VIBE CREDIT UNION BRANCH JSP 20-14

Public hearing at the request of Vibe Credit Union, for Preliminary Site Plan, Wetland Permit, Woodland Permit, and Stormwater Management Plan approval. The subject property is located in Section 15, south of Twelve Mile Road and west of Cabaret Drive, and is zoned OST, Office Service Technology. The applicant is proposing to construct a new 3,684 square foot building with three drive-through lanes and associated site improvements.

PLAN REVIEW CENTER REPORT

Preliminary Site Plan

EMERGENCY VEHICLE MANEUVERING DIAGRAM

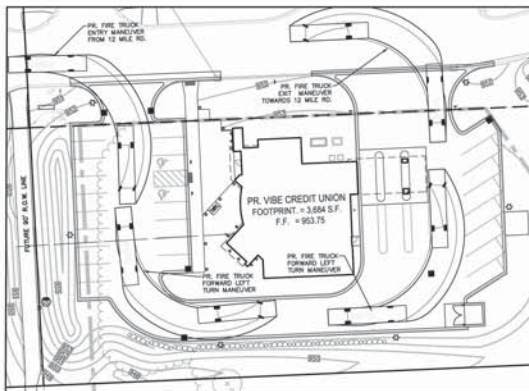
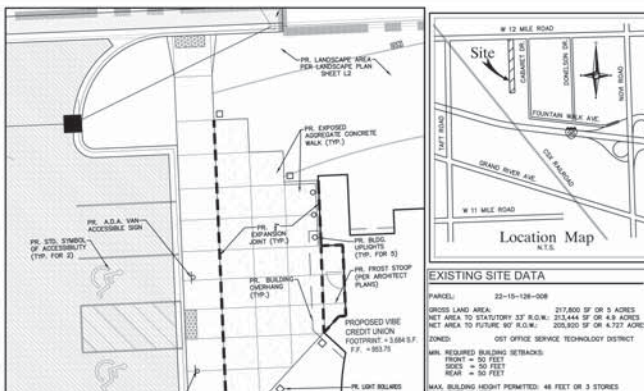
- D. *Drive-through facilities shall provide one bypass lane (minimum 18 feet) to allow unobstructed travel for vehicles to pass those waiting to be served. **Plans show an 18-foot drive aisle that meets the bypass requirements. However, as this is also a Fire Lane the drive is required to be 20 feet wide. See Fire Review letter.***

- An "Emergency Vehicle Maneuvering Diagram" is provided on Sheet C1 showing typical fire truck access provided throughout the site. As part of the final site plan approval process, all proposed geometry for the parking lot and drive lane curbs will be confirmed.

SHEET
Overall Site Plan

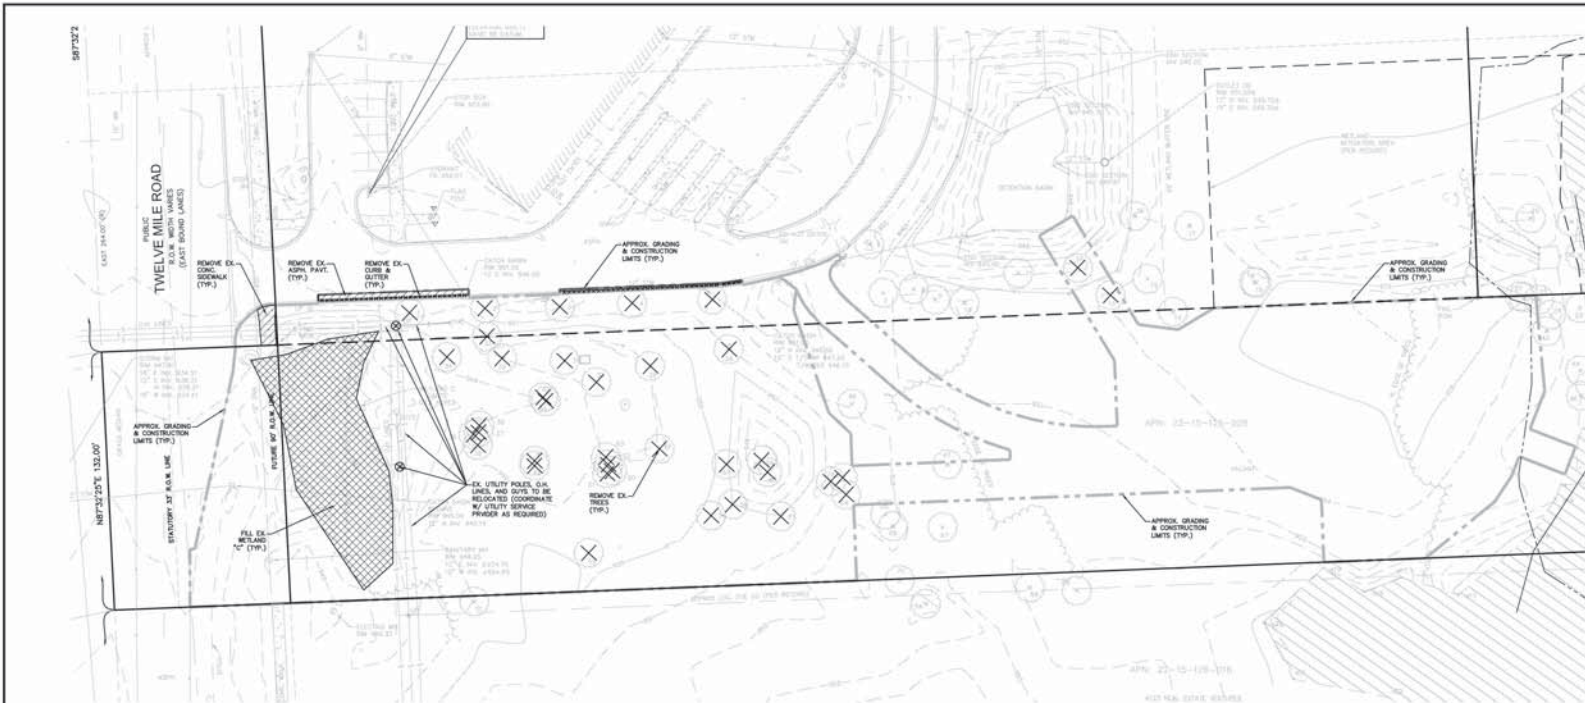
3. Loading Zone (Section 5.4.5): The plans show a loading zone in the drive aisle/fire lane south of the building. **This location is not acceptable. The loading zone must be relocated where it will not impede traffic flow or access to parking spaces. Alternatively, the Ordinance does not require financial institutions to designate a loading space, "provided that the applicant submits documentation concerning the sensitivity of deliveries to the site and the need for those deliveries to occur as near to the door as possible."**

Item	Required Code	Proposed	Meets Code	Comments
(Sec 3.20.2.C)	common boundary with property zoned for R-A, R-1, R-2, R-3, R-4 or MH district use unless conditions in section 3.20.2.C are met			
Outdoor storage (Sec 3.20.2.D)	The outdoor storage of goods or materials shall be prohibited.	Unable to determine. Appears to comply	Yes	Please add note to the plans to clarify
Drive-through Lanes (Sec. 5.3.11)				
Drive-through Lanes Separation (Sec. 5.3.11.A,C)	Drive-through lanes shall be separate from the circulation routes & lanes necessary for ingress to & egress from the property	They are separated.	Yes	
Drive-through setbacks (Sec. 5.3.11.A,B)	Drive through shall follow parking setback requirements and applicable parking lot landscaping requirements	Drive-through conforms to the parking setbacks	Yes	See landscape review for further comments on landscaping.
Bypass Lane for Drive-through (Sec. 5.3.11.D)	Drive-through facilities shall provide 1 bypass lane, min. of 18 ft. in width, unless otherwise determined by the Fire Marshal	A lane is provided – 18 ft. indicated	No	<u>Fire Marshal indicates this will be a fire access lane – 20' width required</u>

- Vibe Credit Union has indicated they do not require a dedicated loading area for this site. The loading area shown on Sheet C1 (10’x40’ area located within the ATM “bypass” lane) will be removed from the drawings in the forthcoming final site plan submittal. Necessary documentation from the Vibe Credit Union indicating that their operations do not require this loading area will also be provided to the City during the final site plan submittal.

- A note will be added to Sheet C1 for the forthcoming final site plan submittal to indicate that outdoor storage of goods/materials will be prohibited.
- As noted above, the southerly “bypass” lane for the ATM banking area will be revised for the forthcoming final site plan submittal to be 20’ in width to meet Fire Department requirements.
- As noted above, designated loading area shown will be removed for forthcoming final site plan submittal, as the Owner will not require a dedicated loading area for this site.
- Response from Architect: We feel our Elevations as currently proposed meet the Intent of the Zoning Ordinance and achieve a proper balance of City of Novi Ordinance requirements and Vibe Credit Union Branding/Prototype goals and we are therefore requesting a Section 9 Waiver for the Elevations as proposed. NOTE: The required façade materials

- c. The recommended "No Left Turn" sign will be added to Sheet C1 for north-bound traffic on the existing site drive to indicate that a left turn into the southerly "exit only" approach is prohibited.

BUILDING ELEVATIONS & MATERIALS

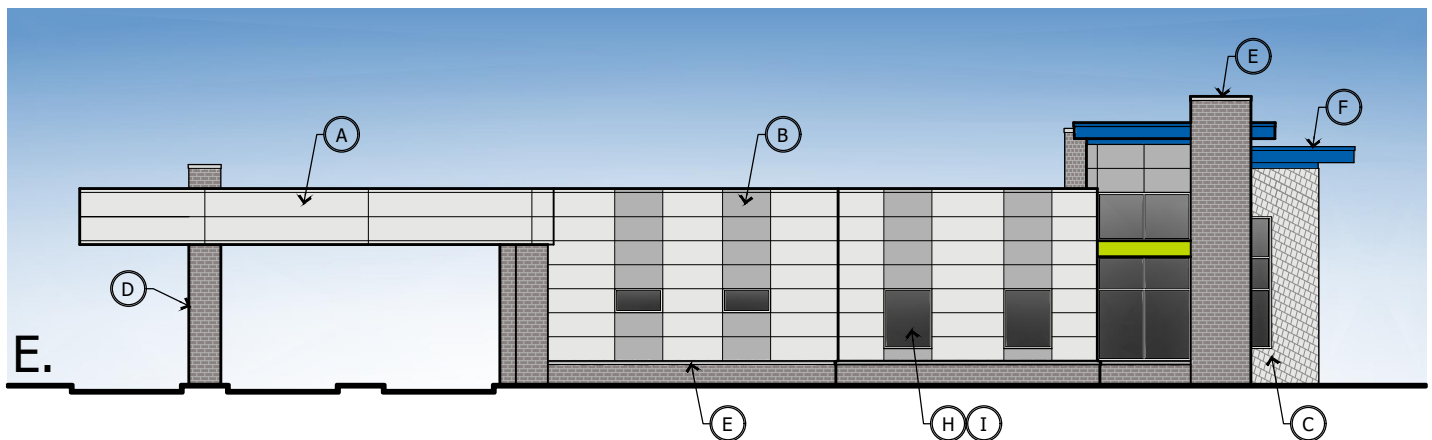
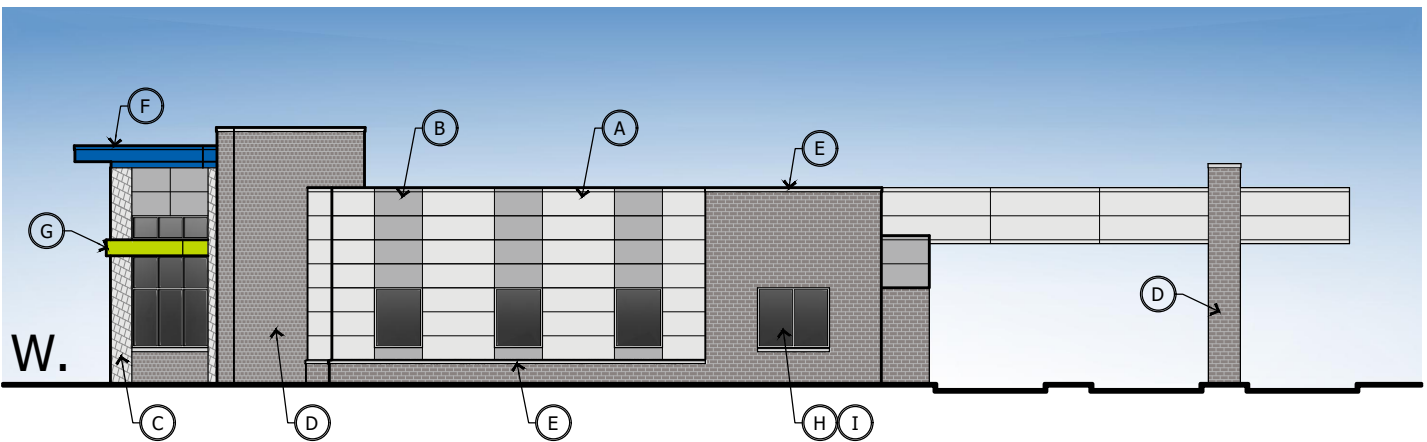
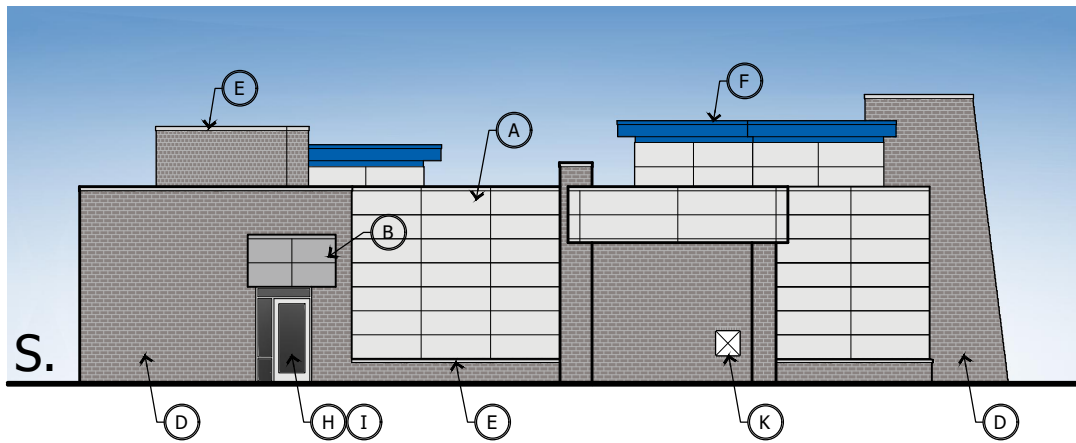
- c. Section 9 Façade waiver for an underage of brick (30% required, 23% proposed) and an overage of Flat Metal Panels (50% allowed, 68% proposed) on the East elevation, *because the proposed design does not adversely affect the aesthetic quality and meets the intent and purpose of the Ordinance, which is hereby granted;*

- Traffic Review: Approval of the Preliminary Site Plan is recommended. Additional comments to be addressed with Final Site Plan submittal.
- Facade Review: **Approval is not recommended at this time.** Revisions should be made to meet the minimum percentage of brick required (30%). A Section 9 waiver for any remaining overage of Flat Metal Panels would then be supported.
